Village of Lakewood

**SPECIAL MEETING
BEFORE THE BOARD OF TRUSTEES**

CONTROL PANEL LANDSCAPE PLANNING MEETING

Action Items Status following Lakewood Resident Meeting

**VILLAGE OF LAKEWOOD/BROADWAY AVE
PROPOSED WISCONSIN GRANITE COBBLESTONE SHOULDER**

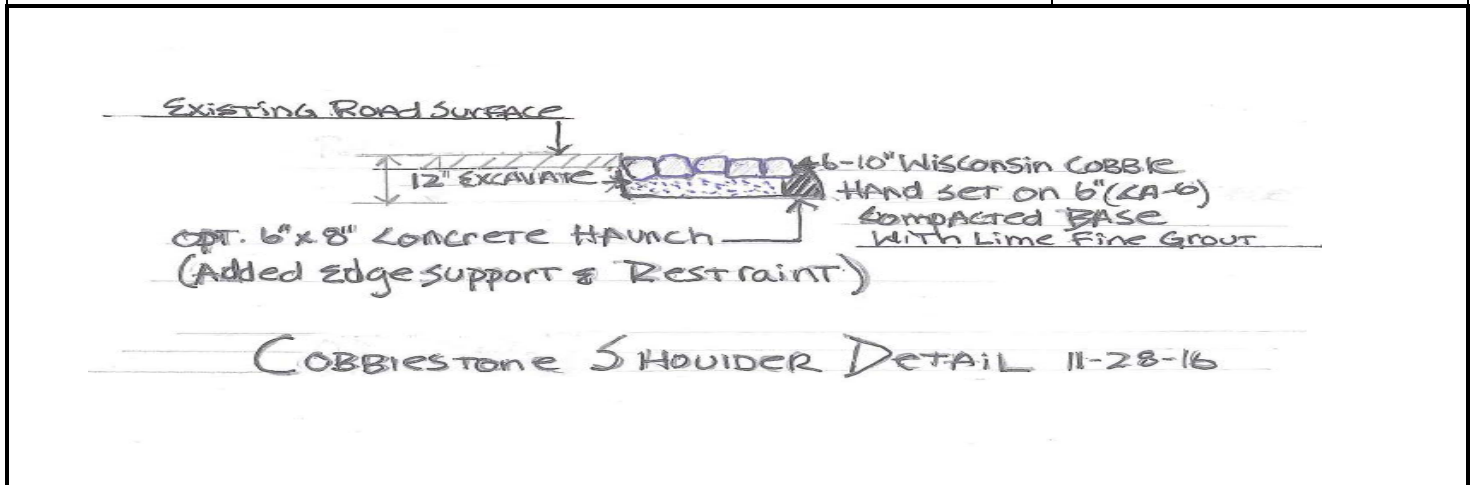
SEE DETAIL BELOW

LOCAL DUMP LOCATION TO BE PROVIDED BY OWNER FOR EXCAVATED MATERIAL.
